186th session

Proposal for amendments to the Consolidated Resolution on the common specification of light source categories (R.E.5)

Proposal for amendment 8 to the Consolidated Resolution on the common specification of light source categories (R.E.5)

Submitted by the Working Party on Lighting and Light-Signalling*

Figure 1*
Main Drawing

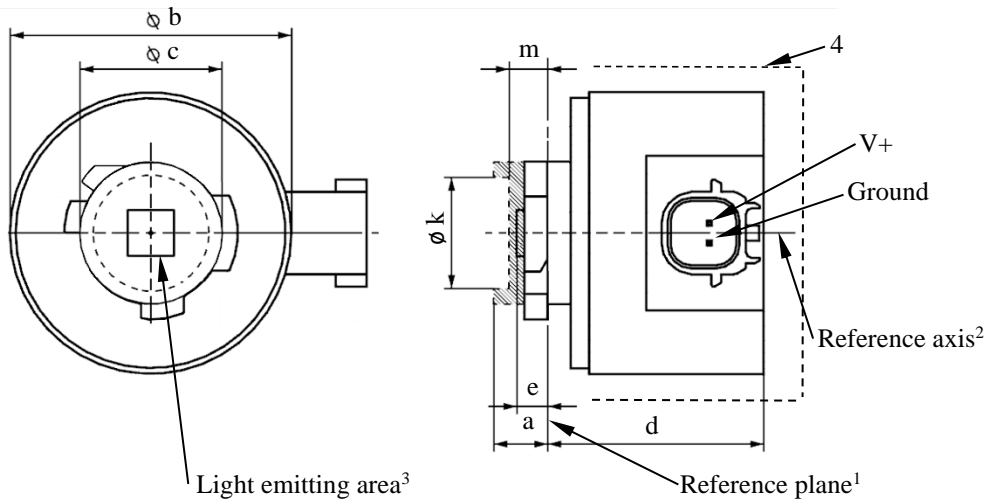
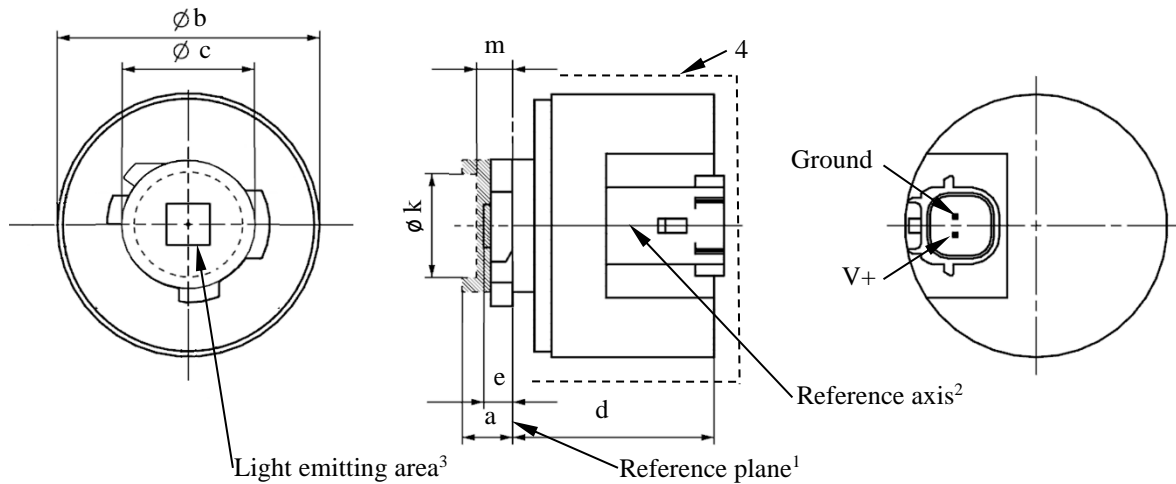
After sheet Lx5/6, insert new sheets Lx6/1 to 6, to read (see following pages; one page per sheet):

Dimensions		Production LED light sources	Standard LED light sources
a	mm	6.0 max.	
b	mm	c + 10.0 min. 38.0 max.	
c	mm	18.5 ± 0.1	
d	mm	28.0 max.	
e ^{8/}	mm	3.0 ± 0.30	3.0 ± 0.15
k ^{9/}	mm	7.5 min.	
m ^{9/}	mm	4.0 max.	
Cap	LR6A, LR6B	PGJ18.5d-33	in accordance with IEC Publication 60061 (sheet 7004-185-3)
<i>Electrical and photometric characteristics</i>			
Rated values	Volts	12	
	Watts	7	
Test voltage	Volts (DC)	13.5	
Objective Values ⁶	Watts (at test voltage)	8 max.	
	Luminous flux (in lm at test voltage) ⁵	180 ± 15%	180 ± 10 % ⁷
	Luminous flux (in lm at 9 V DC) ⁵	40 min.

Figure 2
Box definition of the light emitting area with dimensions as specified in Table 2

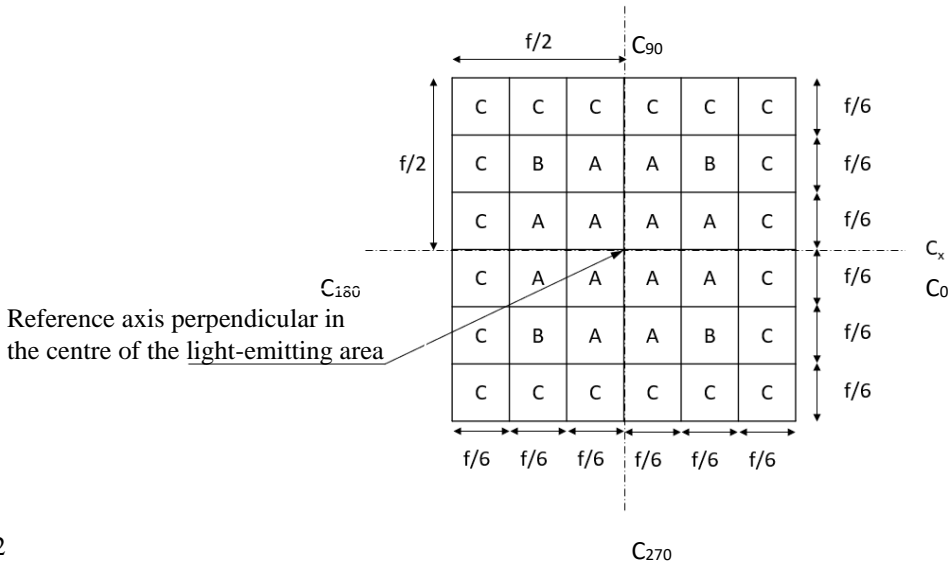
The position of the light emitting area is checked by the box system defined in Figure 2, which is aligned to the planes C₉₀ and C₁₈₀ and shows the projection when viewing along direction $\gamma = 0^\circ$ at $e = 3.0$ mm (C, γ as defined in Figure 3). The luminous flux Φ emitted into the viewing direction shall be calculated as given below:

<i>Area(s)</i>	<i>LED light sources of normal production</i>	<i>Standard LED light sources</i>
Each A individually	> 3% < 10 %	> 4% < 10%
Each B individually	> 3% < 10%	> 3% < 10%
All A and B together	> 70%	> 75%
Each C individually	< 2%	< 2%
All A, B and C together	> 90%	> 90%

Figure 3
Set-up to measure the luminous intensity distribution

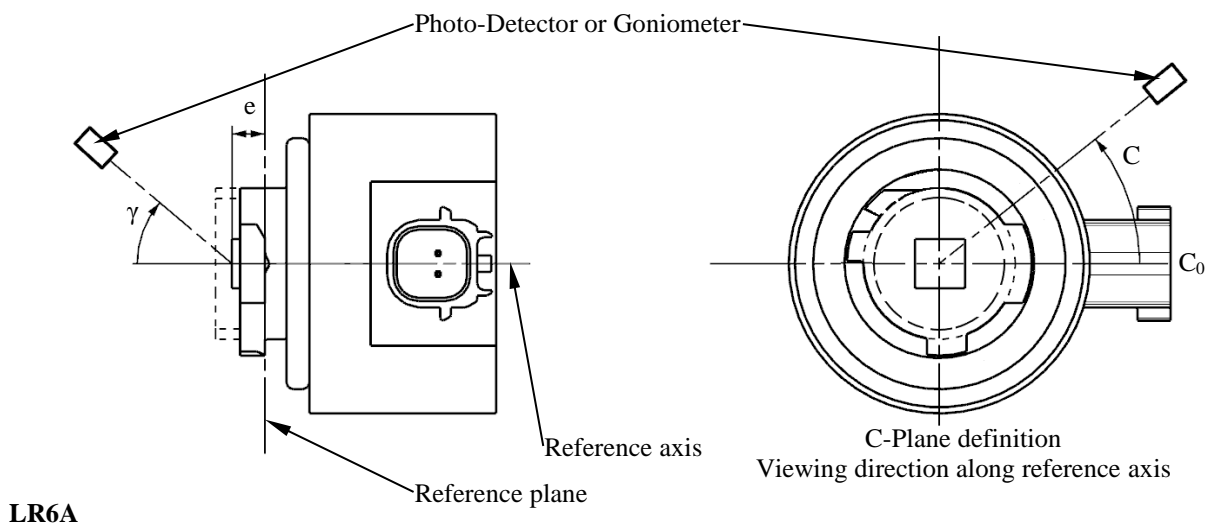
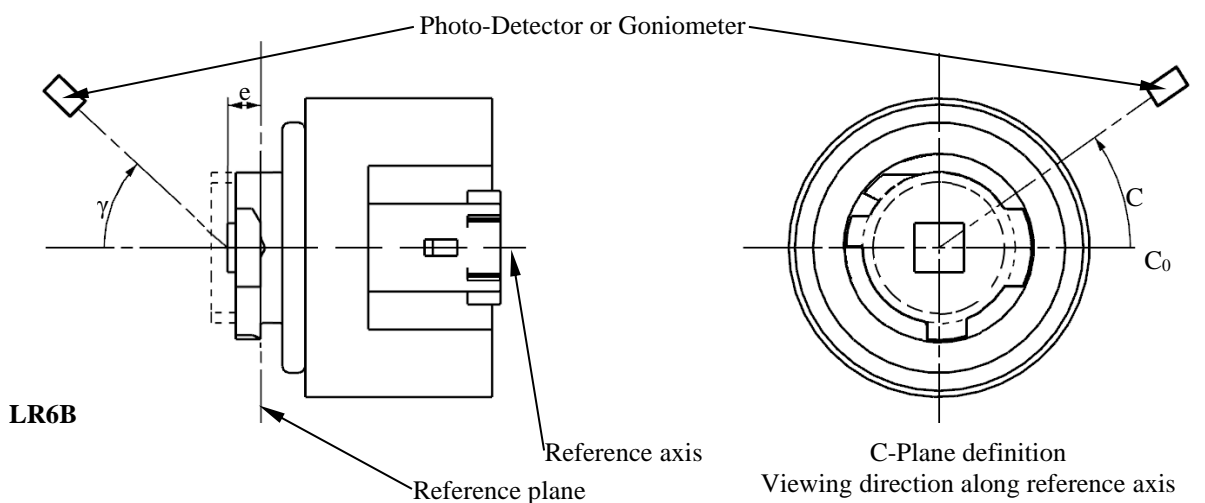
The light source is mounted on a flat plate with the corresponding mounting lug features. The plate is mounted to the goniometer table by a bracket, so that the reference axis of the light source lines up with one of the rotating axes of the goniometer. The corresponding measurement set-up is described in Figure 3.

<i>Angle γ</i>	<i>LED light sources of normal production</i>		<i>Standard LED light sources</i>	
	<i>Minimum Intensity in cd /1000 lm</i>	<i>Maximum Intensity in cd/1000 lm</i>	<i>Minimum Intensity in cd /1000 lm</i>	<i>Maximum Intensity in cd /1000 lm</i>
0°	200	425	250	390
15°	190	415	240	370
30°	170	380	220	335
45°	145	310	180	275
60°	85	245	105	220
75°	0	160	0	150
90°	0	70	0	65
